### Jacobs - Review of AER Draft Decision - REPEX

AUSGRID

Review of AER Draft Decision - REPEX

RO008302RP00044 | Final

Figure 1: Asset Replacement Life Variance

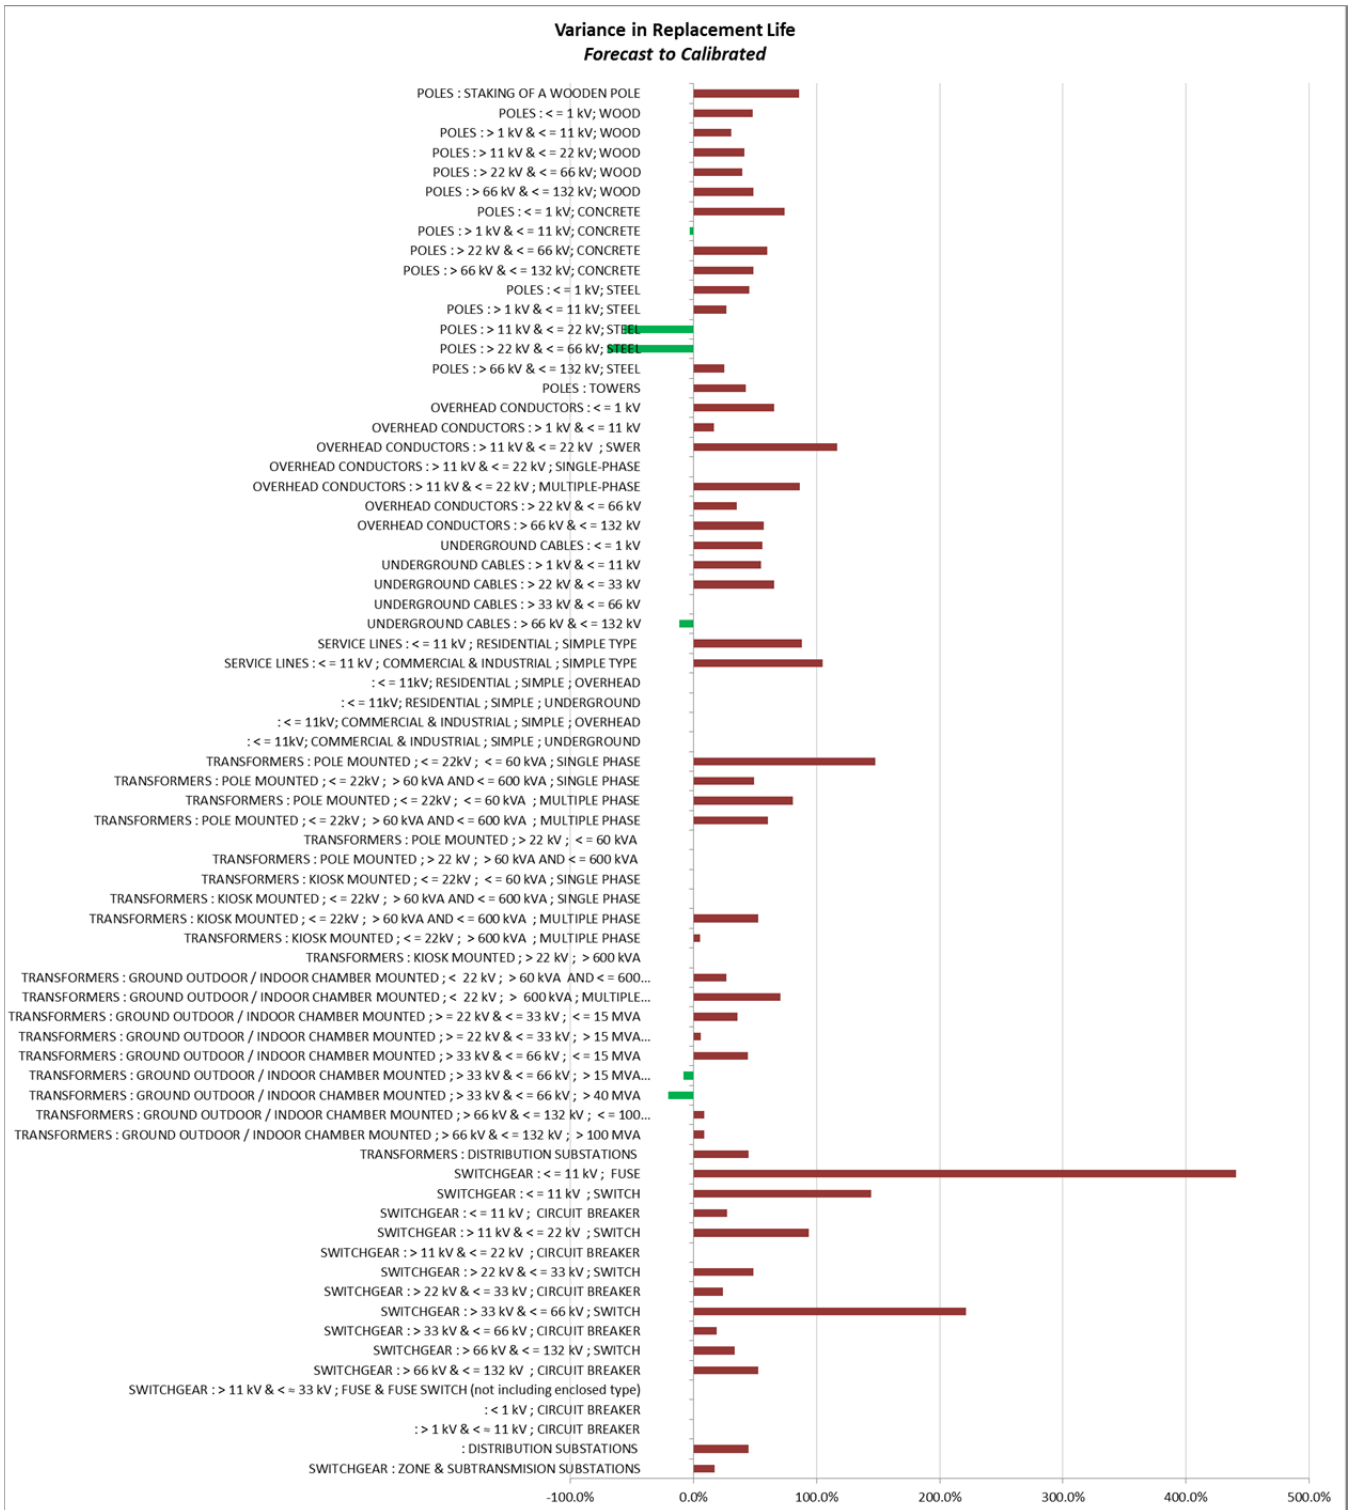
The calibrated mean replacement lives applied to the Ausgrid forecast is generally much longer than industry experience. Figure 1 provides an overview of the percentage variance between Ausgrid's proposed replacement lives and the AER's Calibrated replacement lives. For the vast majority of assets the replacement lives have been extended and in most cases with more than 30%. The result of the life extensions is a reduction in the volume of replacement requirements and a downward adjustment of the replacement forecast.

Figure 2: Asset Replacement Unit Cost Variance

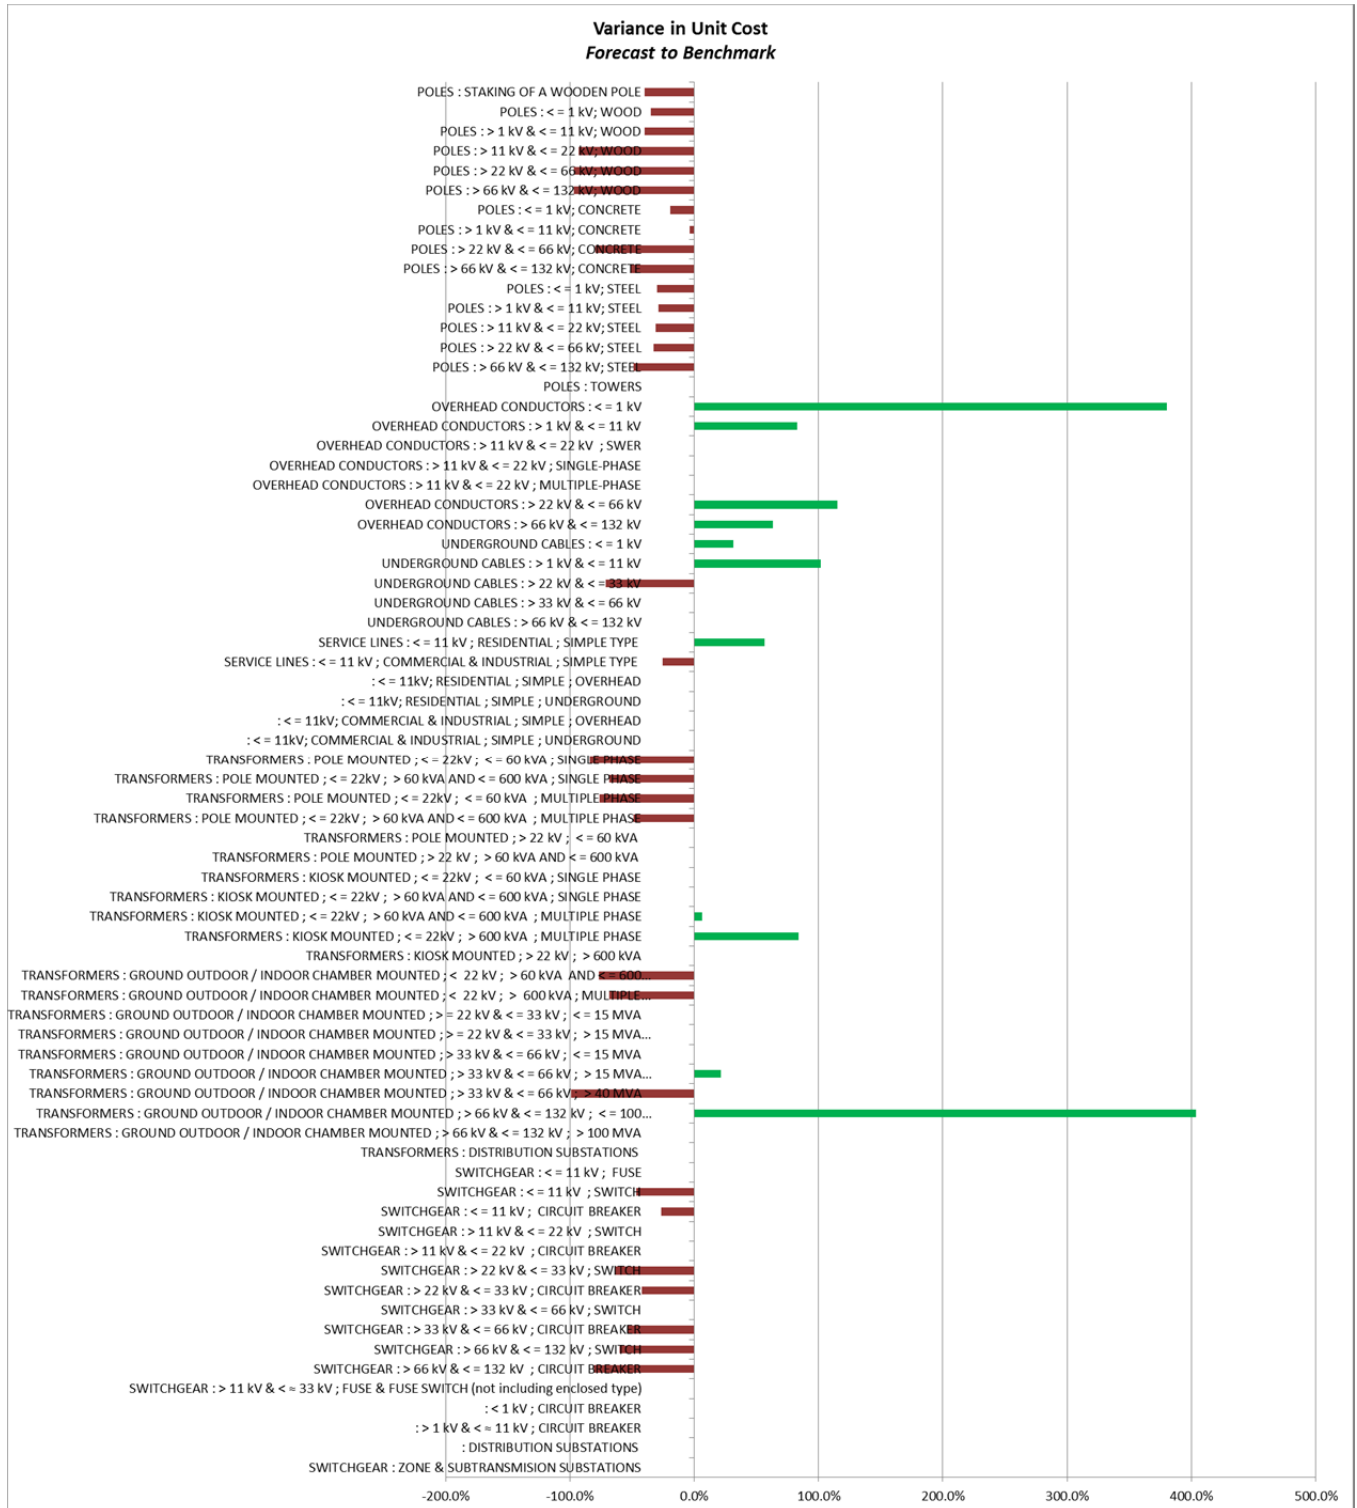
The AER unit rates vary both upward and downward in comparison with the Ausgrid unit costs across the asset categories. The downward adjustments appears, however, to be more heavily weighted towards the higher ranking cost asset categories with the unit rates for pole replacement down on average with around 45%, pole mounted transformers 46%, and switchgear 31%. The unit rates for cables, conductors, and services are adjusted upwards on average between 12% and 45%. The result of these variances is a significant downward adjustment in for example the forecast for pole replacements which drops from Ausgrids' \$300m to the Calibrated Benchmark forecast of \$40m.
